# Site Accessibility Evaluation

### **Madison Park**

**Accessibility Evaluation**

SUBJECT: Madison Park Self-Evaluation

Finding 189108 Main Photo

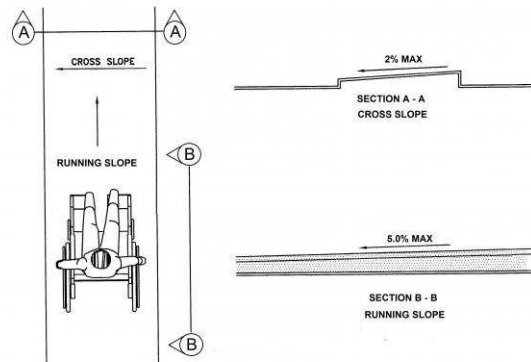
**The accessible path of travel contains cross slopes greater than 2%.**

**The cross slope of the sidewalk that runs along Murray Blvd has eight pads of concrete with excessive cross slope as high as 6.5%.**

**Remove and replace the pads to compliance.**

Finding 189110 Main Photo

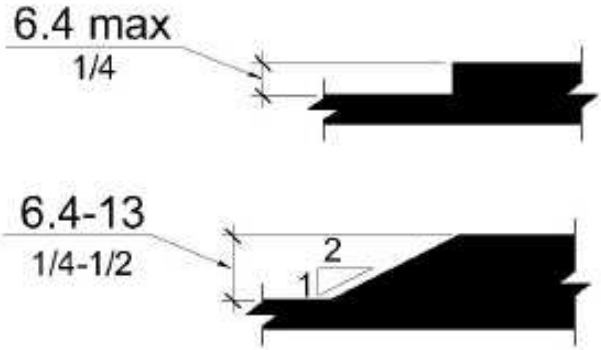
**The surface of the pedestrian access route has vertical discontinuities greater than 1/2 inch or between 1/4 inch and 1/2 inch that are not beveled.**

**There are four areas along Murray where pads have lifted/sunk causing vertical displacements ranging from 1/2" to 1".**

**Grind to less than 1/2" bevel where possible or replace pads.**

Finding 191707 Additional Photo

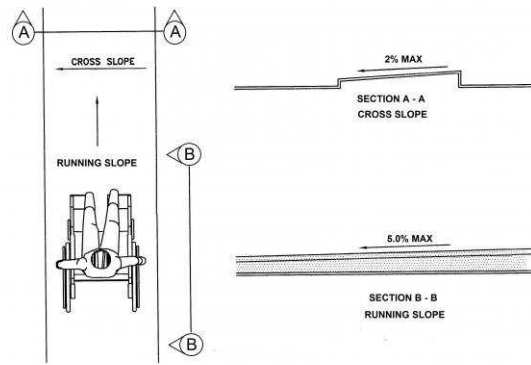
The accessible path of travel has cross slopes greater than 2%.

There are 75 pads of concrete on the route along Northglenn with excessive cross slope as high as 5.6%.

Remove and replace pads to compliance.
